RE: WHITEHAVEN SOLAR FARM – RESPONSE TO REQUESTS FOR ADDITIONAL INFORMATION

2.1.2 RFI Dated 13 August 2025

Figure 1; Extract ex EIS Figure 1.2 Indicative Project General Arrangement (Whitehaven Energy Pty Ltd 2024)

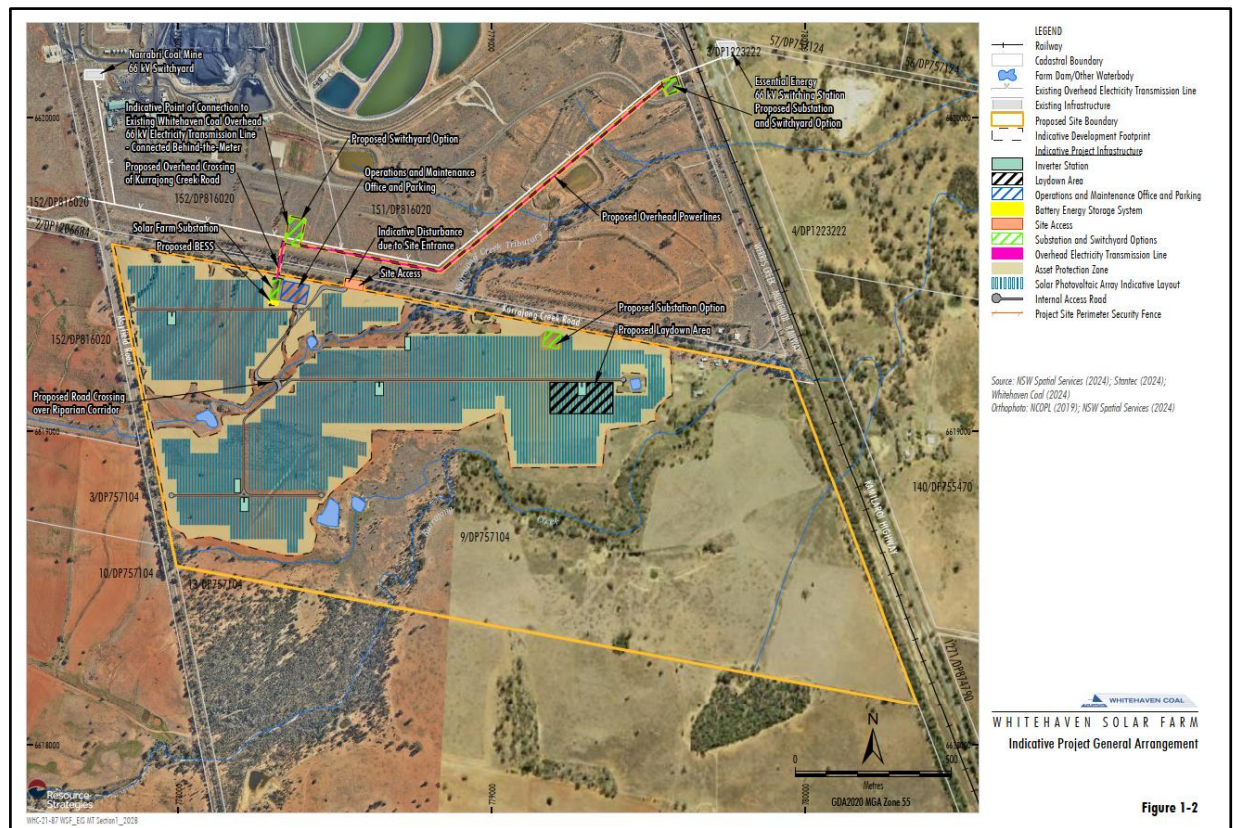
It is noted that within the supplied EIS Figure 1-2 Indicative Project General Arrangement (Figure 1) an asset protection zone has been shown although to comply with the recommendations of this report some minor adjustments to this plan will be required.

ATTACHMENT 2 – ‘DESIGN VEHICLE’ SWEPT PATH ANALYSIS

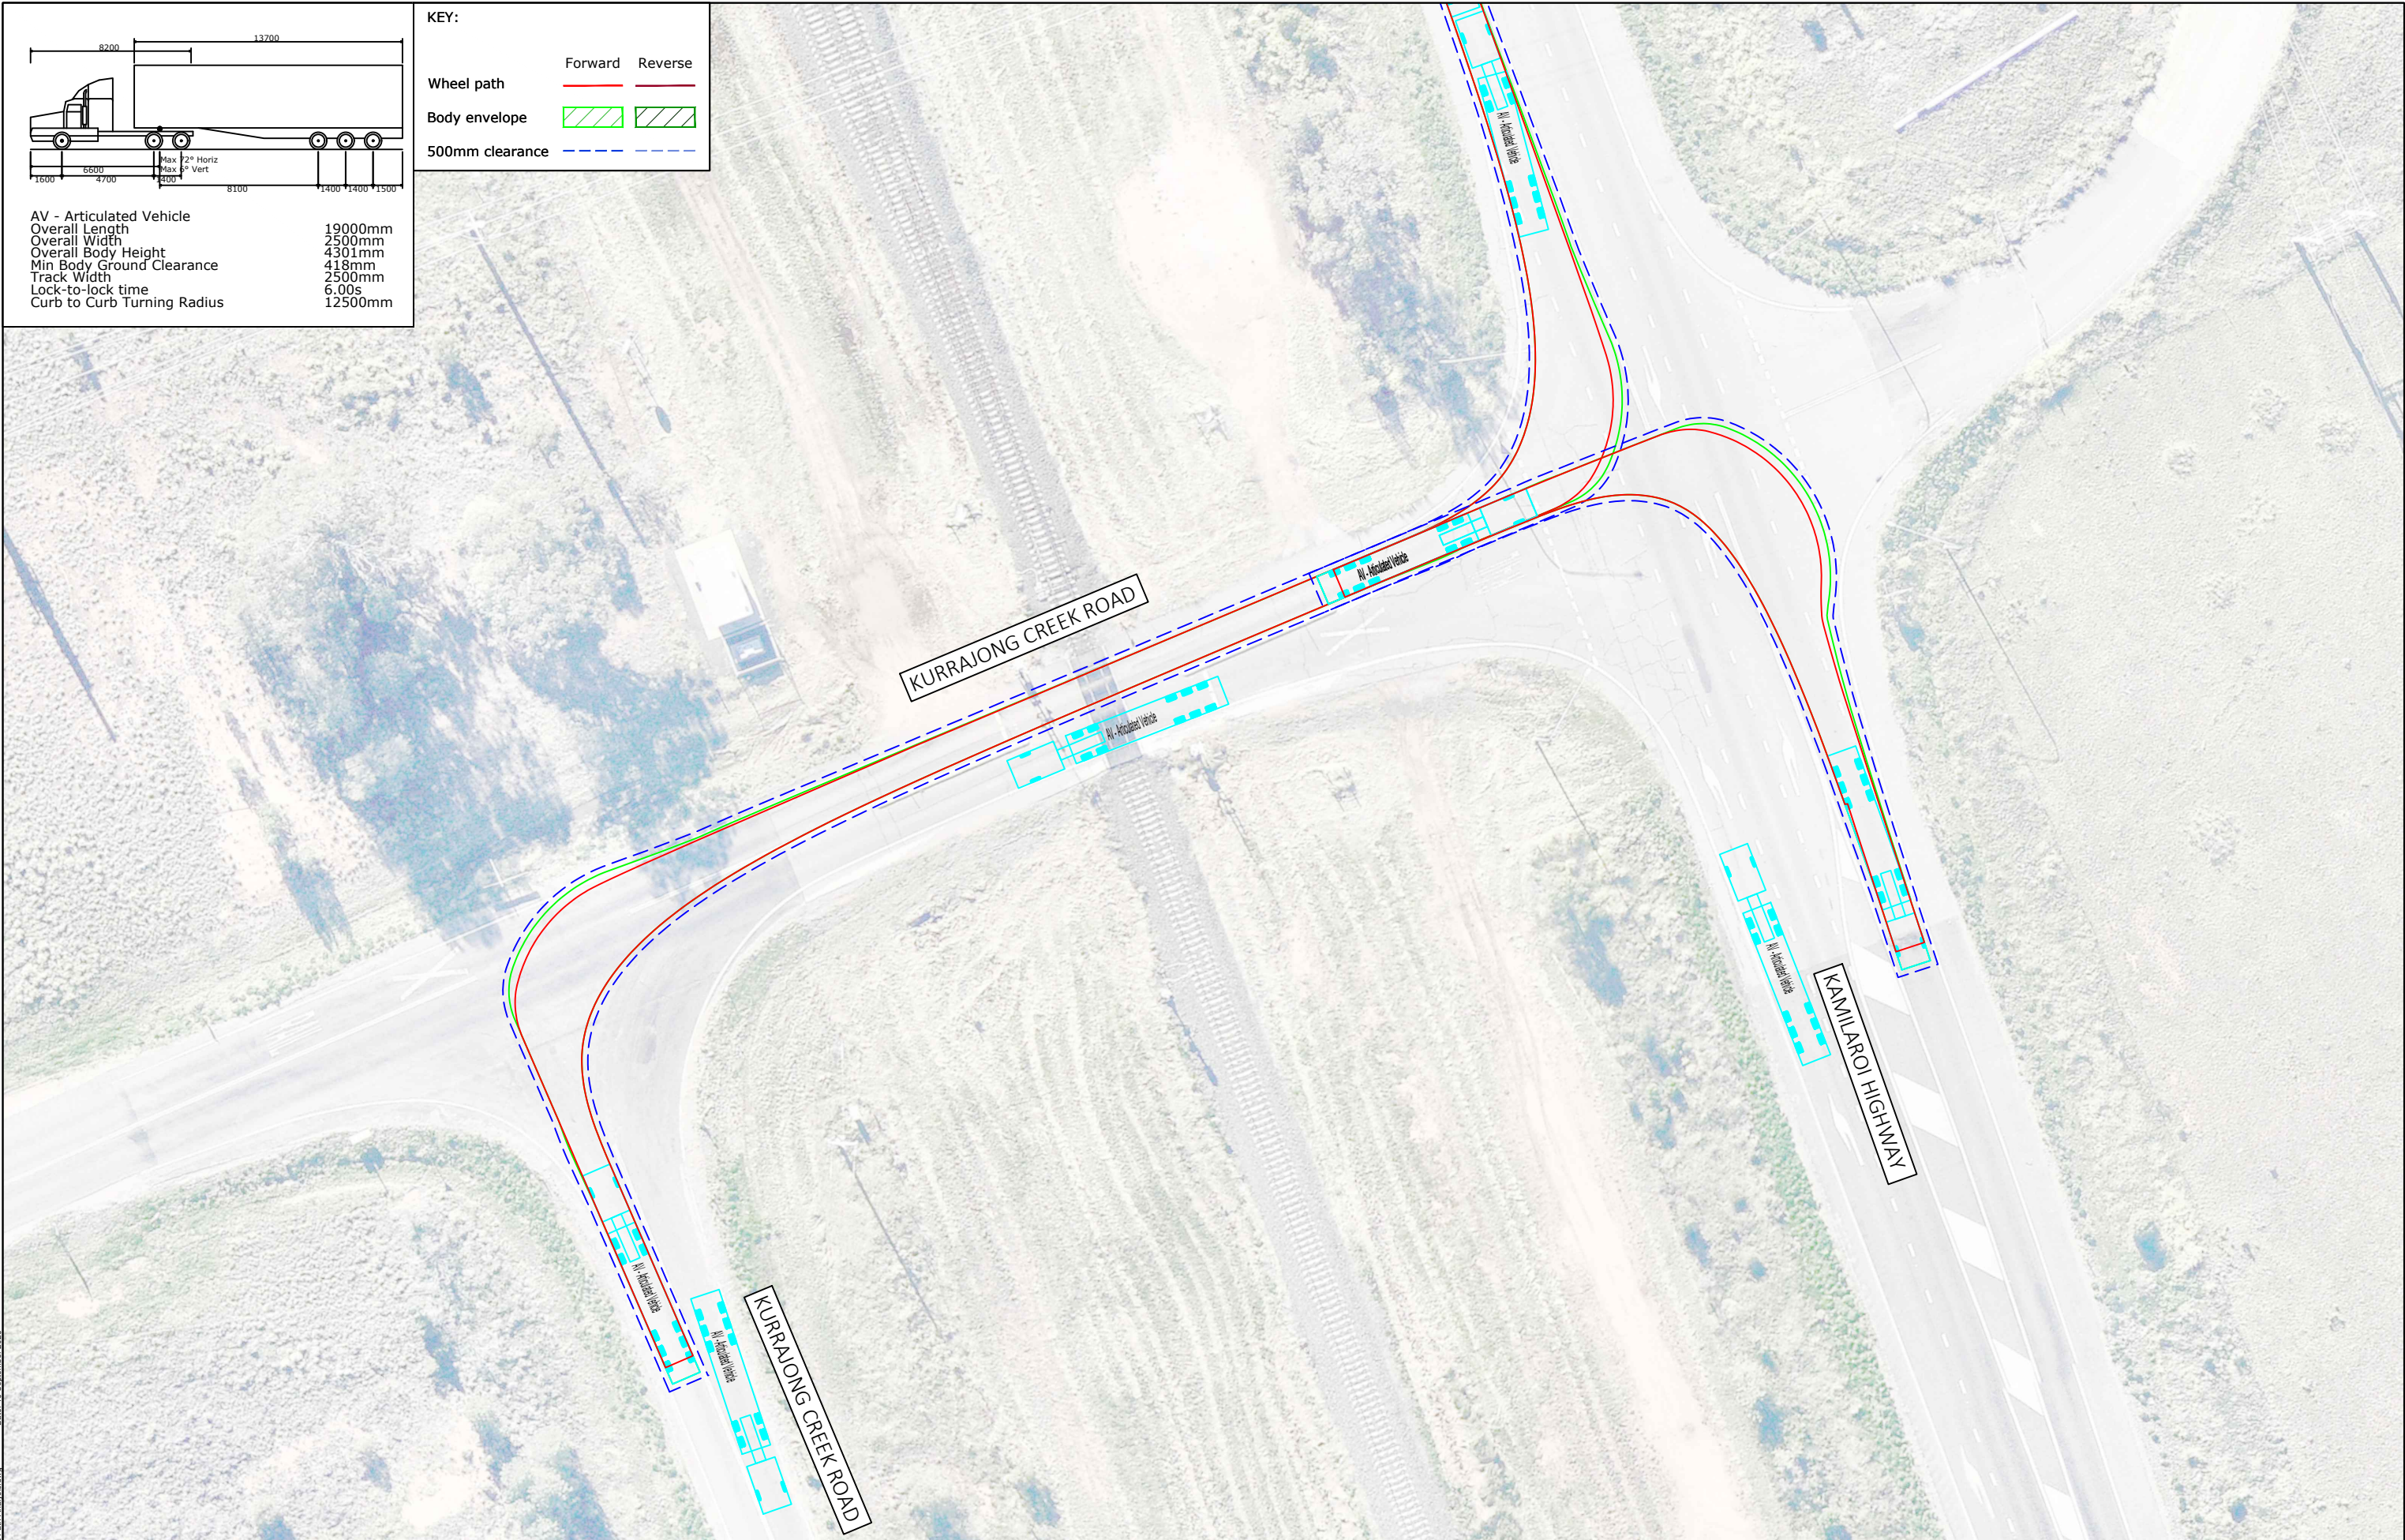
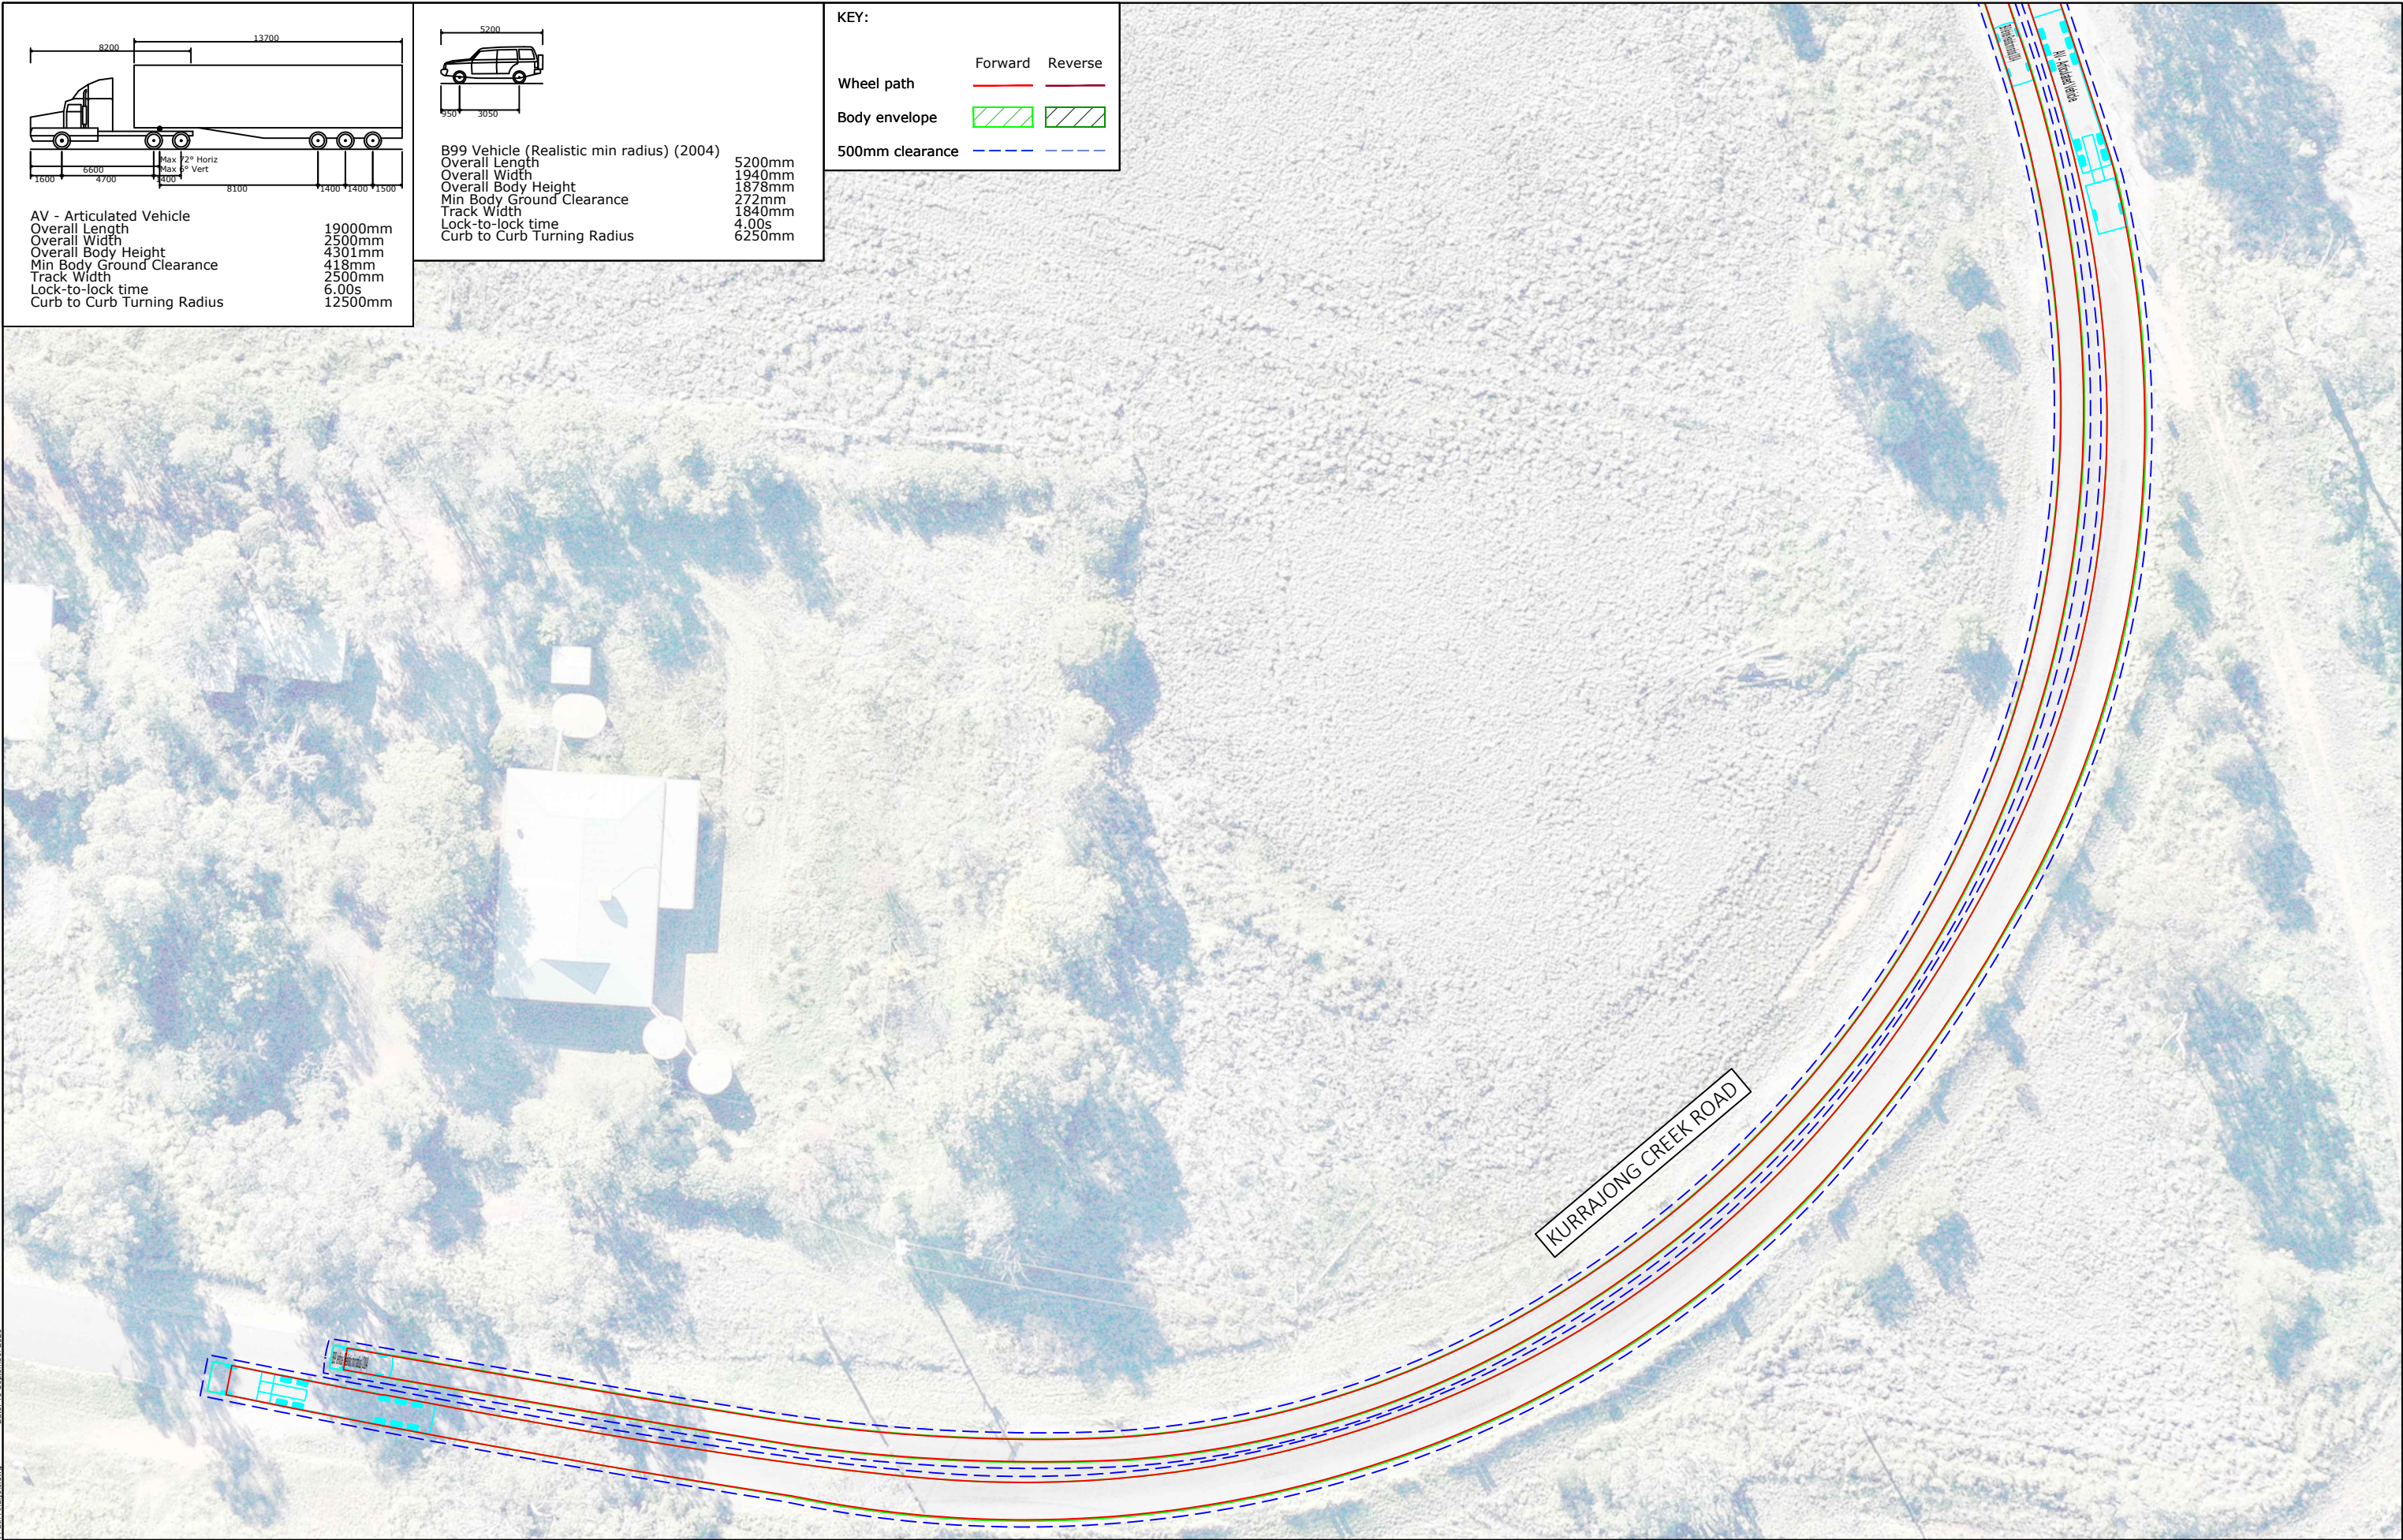
Comment/Recommendation

Please refer to Attachment 2 for the swept path analysis of the design vehicle (prepared by The Transport Planning Partnership). The analysis shows that the design vehicle can turn on the existing pavement at the relevant intersections.
